1968 Corvette: Service Bulletin: Gas Line Rattle

Subject: Gas Line Rattle
Model and Year: 1968 Corvette
Source: Chevrolet Dealer Service Information Bulletin - General Motors Canada
Bulletin No: 68-IC-54
Section: Chevrolet
Date: June 29, 1968

Fig. 1.

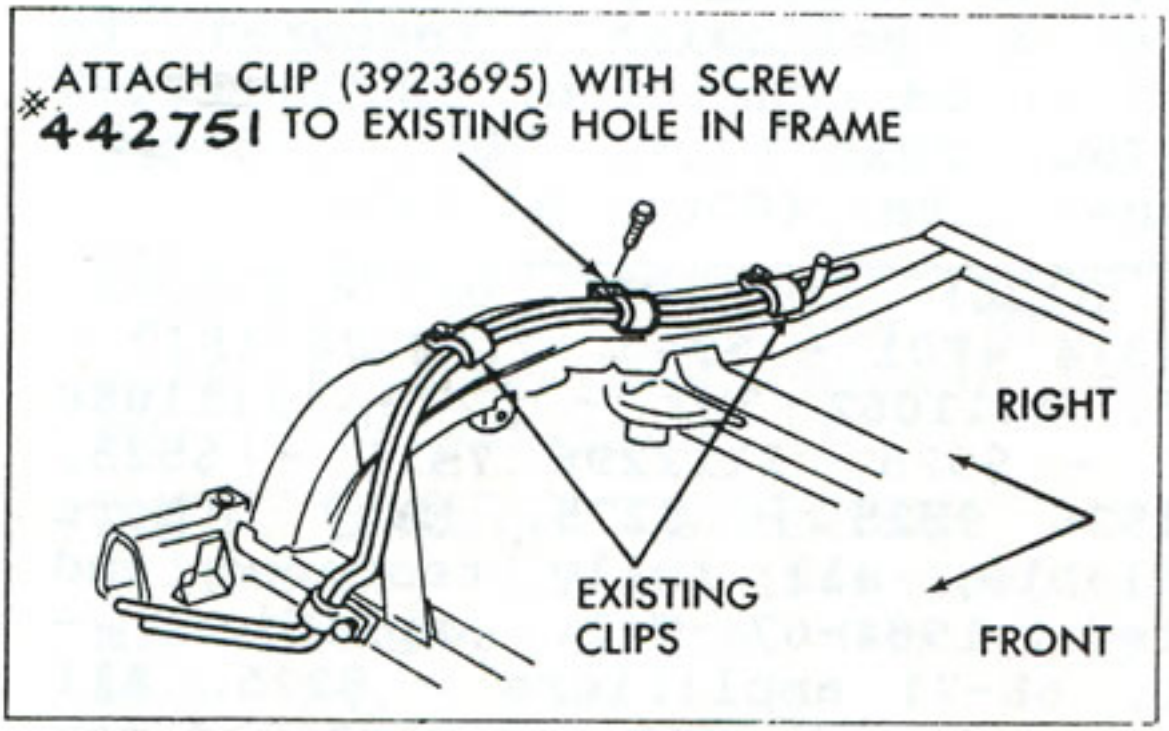
A rattling or "ticking" noise from the rear of the vehicle has been experienced on some 1968 Corvettes. This noise is resulting from the fuel supply line vibrating against the return line. Production has corrected this condition by installing an additional clip in the existing frame hole at this location. Refer to Fig. 1. This same correction is recommended for units in the Field that are experiencing the rattling or "ticking" noise. Fig. 1 illustrates where the clip should be added and gives the related parts data.
